CITY OF OREM
DEPARTMENT OF DEVELOPMENT SERVICES

RE: I-15, Utah County – Salt Lake County Final Environmental Impact Statement (FEIS) Comments

RE: I-15 Draft Environmental Impact Statement (DEIS) Comments

Re: Comments on I-15 Corridor Utah County to
Salt Lake County, Final Environmental Impact
Statement (FEIS): CEQ#: 2008024

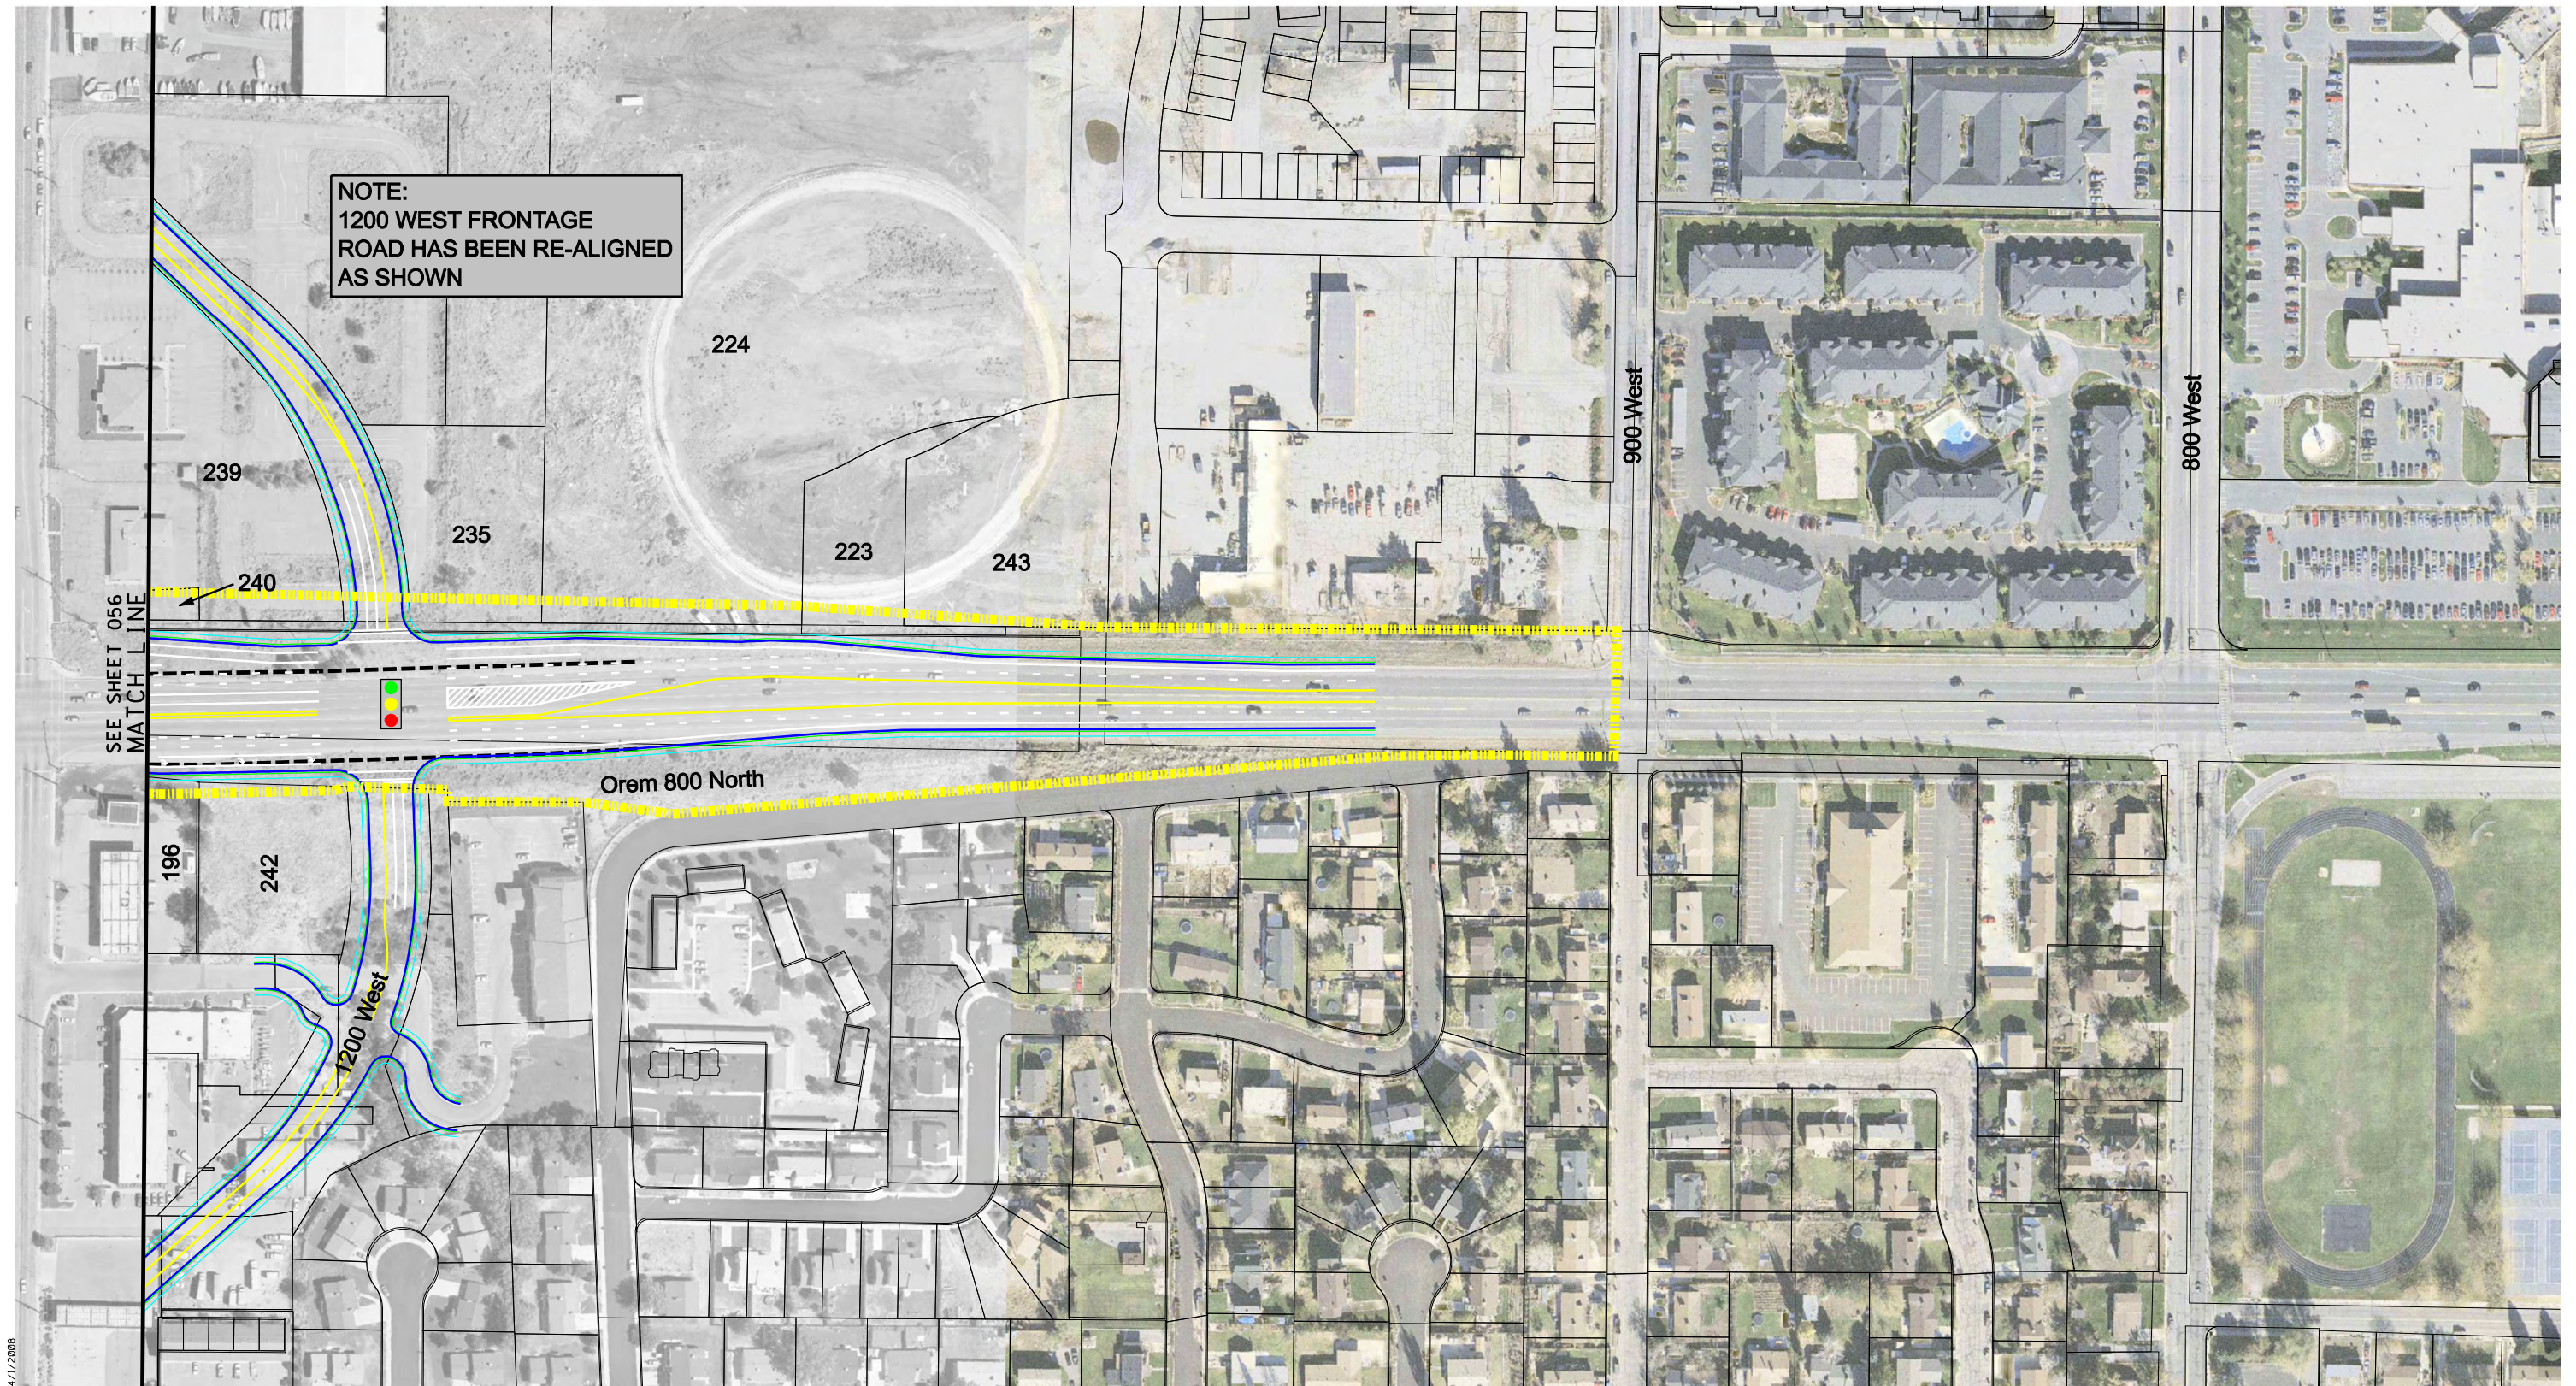
Ed and I both believe that the neighborhood streets (40 South and 85 South) need to be connected to 1200 West and 1000 West for the following reasons:

1. The streets currently have connections to Center Street on both ends (currently at 1160 West and 1000 West).
2. Our subdivision ordinance indicates that dead-end / no-outlet type roads should not be longer than 650 feet (to comply with the International Fire Code). If 85 South and 40 South only connect to 1000 West the length to the end of the no-outlet road would be well over 1000 feet.
3. The road grade connecting the streets to 1000 West is very steep and would be difficult to maneuver in snow and ice conditions.

We would like to explore a possible connection of 40 South and 85 South to 1200 West on the property you label as #80, because we don't want an off-set intersection condition on 1200 West and the access should be as far away from the intersection as possible.

Also, we would like to explore options of how to connect access to the office buildings on Center Street to 1200 West. They currently have access to Center Street at 1160 West (the street where UDOT proposes to re-align 1200 West). They should continue to have access to Center Street from this area; however, we would like to explore ways to not have their access too close to Center Street on 1200 West. Also, we would like to explore ways of connecting the vacant property north of Center Street to 1200 West. This property is shown as Commercial on our General Plan, and the raised median and widening proposed on Center Street may severely restrict it's use without reasonable access.

Sheet: HWY-049D

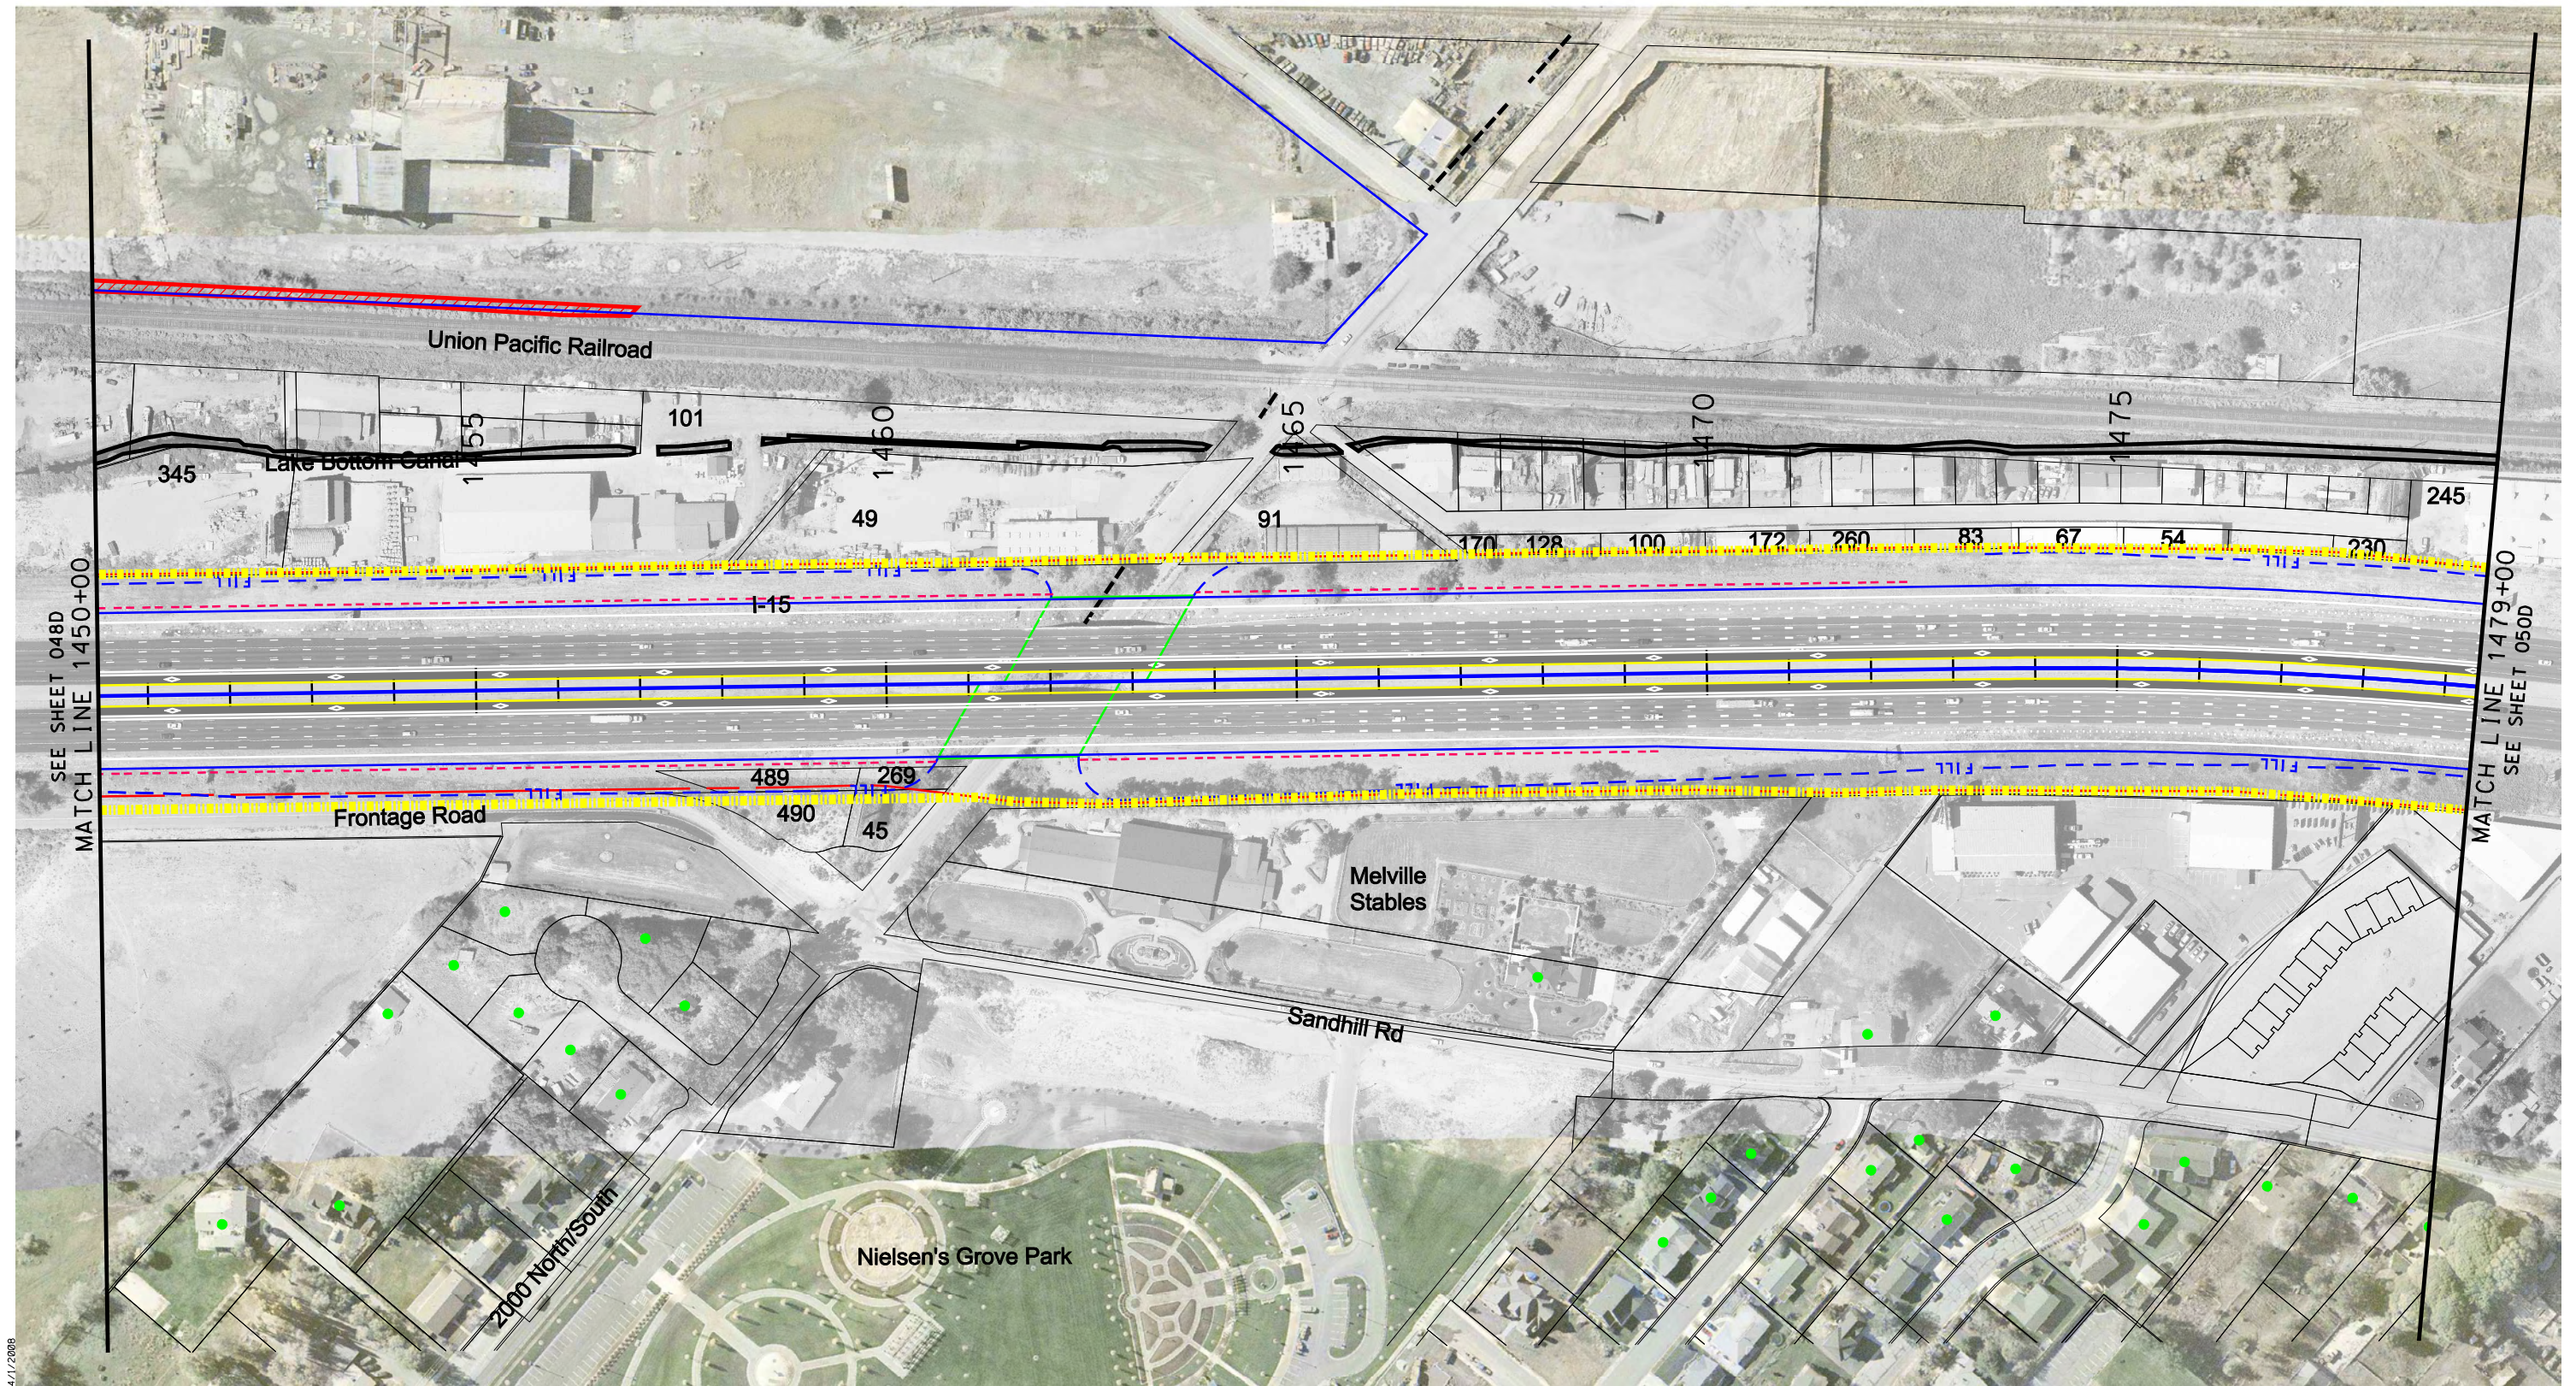
- University Parkway (Vol II, Section: Option D, Sheet: HWY-051D, HWY-051.1D), and
 - 2000 South (Vol II, Section: Option D, Sheet: HWY-049D)

Sheet: HWY-051D
I-15 WIDENING & RECONSTRUCTION

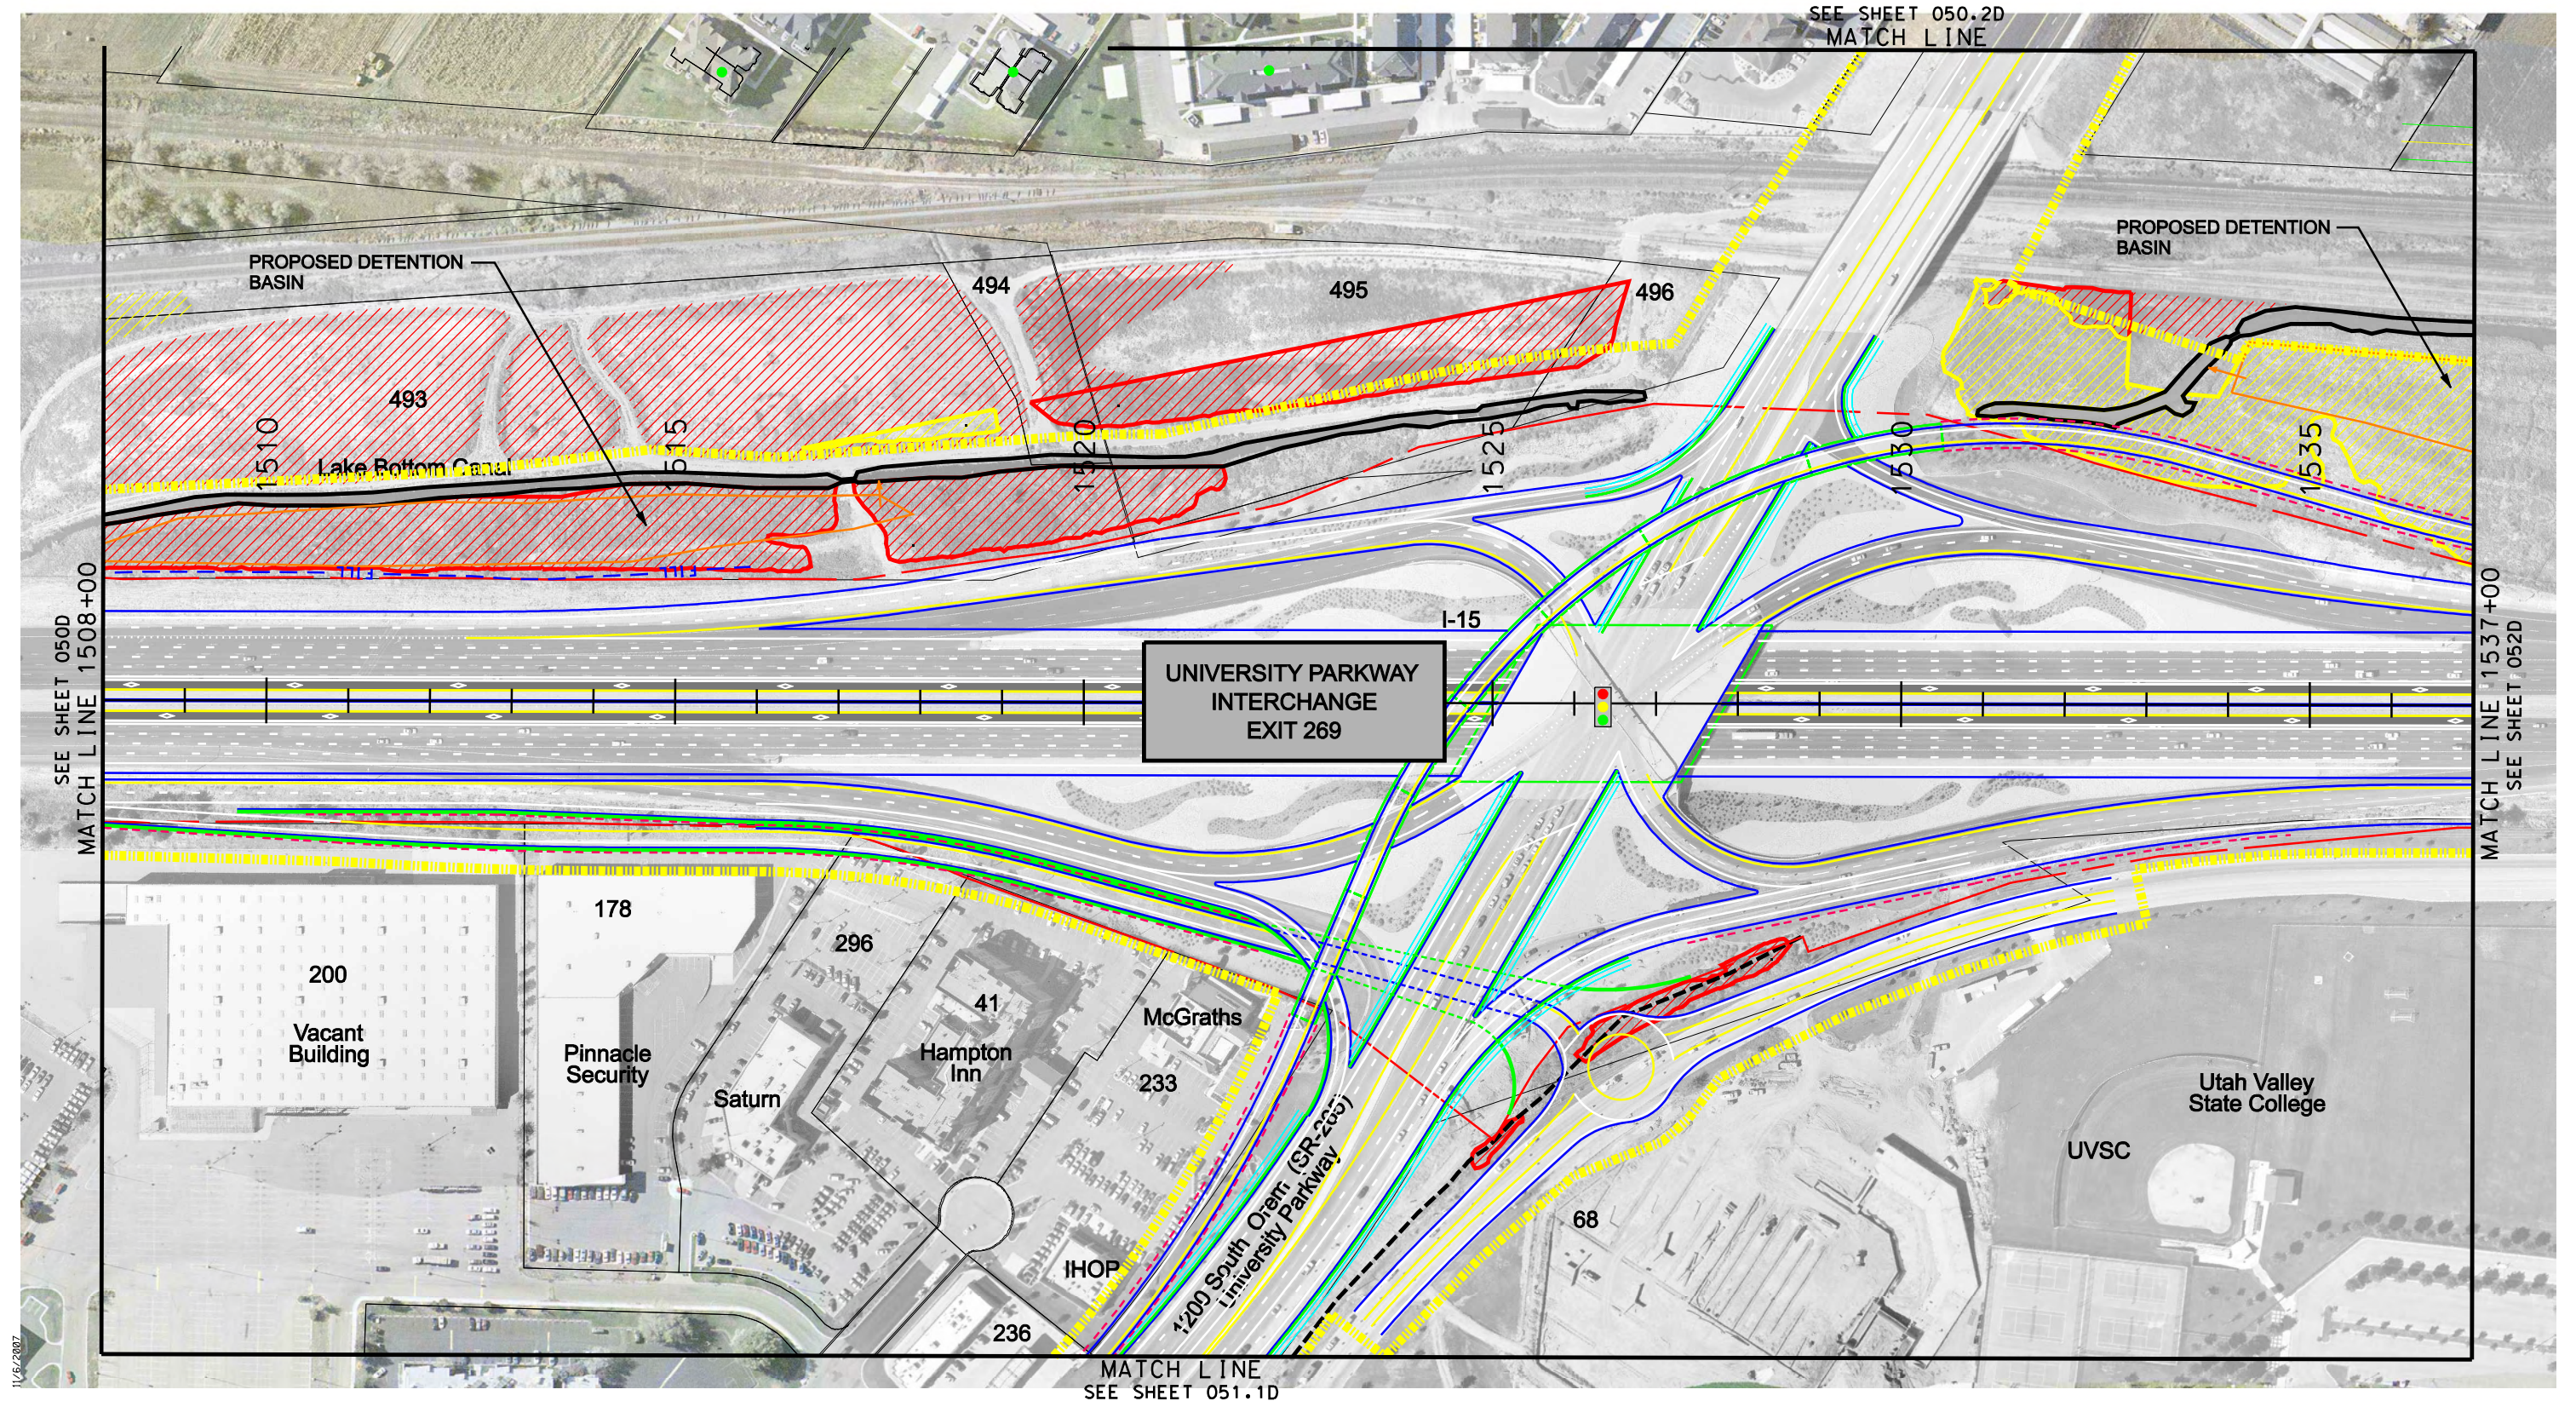
6. We have concerns over the dramatic change in the illustrated design of the Option D Flyover at University Parkway between the Draft Environmental Impact Statement (DEIS) with three travel lanes in each direction east of I-15 (Attachment E) that in the FEIS has been re-designed to two eastbound travel lanes before picking up the Flyover as the third lane east of Sandhill Road (Attachment F).
